SUB-COMMITTEE ON SHIP SYSTEMS AND
EQUIPMENT
4th session
Agenda item 12

SSE 4/12/12
13 January 2017
Original: ENGLISH

**UNIFIED INTERPRETATION TO PROVISIONS OF IMO SAFETY,
SECURITY, AND ENVIRONMENT-RELATED CONVENTIONS**

**Clarification on the application of SOLAS regulation II-2/20.6.2 and MSC.1/Circ.1275
regarding the arrangement of portable fire extinguishers
for ro-ro spaces and vehicle spaces**

Figure 1: Distance between fire extinguishers as per SOLAS regulation II-2/20.6.2

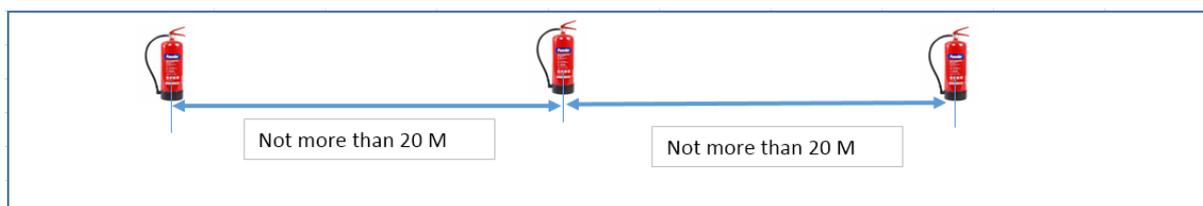
- .1 the distance between two consecutive fire extinguishers is to be a maximum of 20 m, in accordance with SOLAS regulation II-2/20.6.2 (see figure 1 below); or
- .2 the maximum distance between two consecutive fire extinguishers can be 40 m, in accordance with the interpretation in MSC.1/Circ.1275 (see figure 2 below).

7 Having carefully considered the matter, the co-sponsors have agreed that the mandatory SOLAS requirement is to prevail over the non-mandatory interpretation in the MSC circular where any inconsistency exists between the two instruments. Hence, the co-sponsors are of the opinion that the distance between two consecutive fire extinguishers is to be a maximum of 20 m, on both sides of the space, in accordance with SOLAS regulation II-2/20.6.2.1.

Figure 2: Distance between fire extinguishers as per MSC.1/Circ.1275

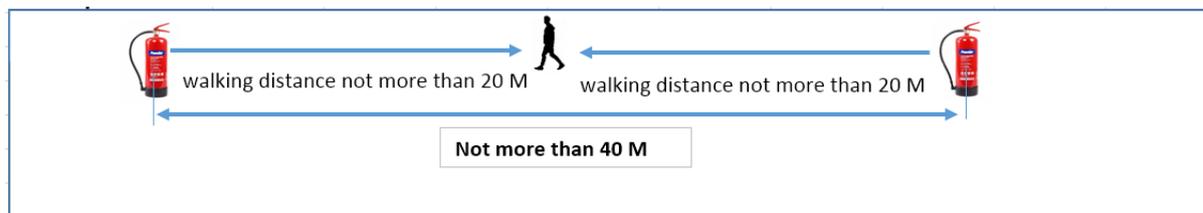
8 Taking into account paragraphs 6 and 7 above, the co-sponsors consider that this specific part of MSC.1/Circ.1275 needs to be reviewed and amended, in order to facilitate the global and consistent arrangement of portable fire extinguishers in ro-ro spaces and vehicle spaces.
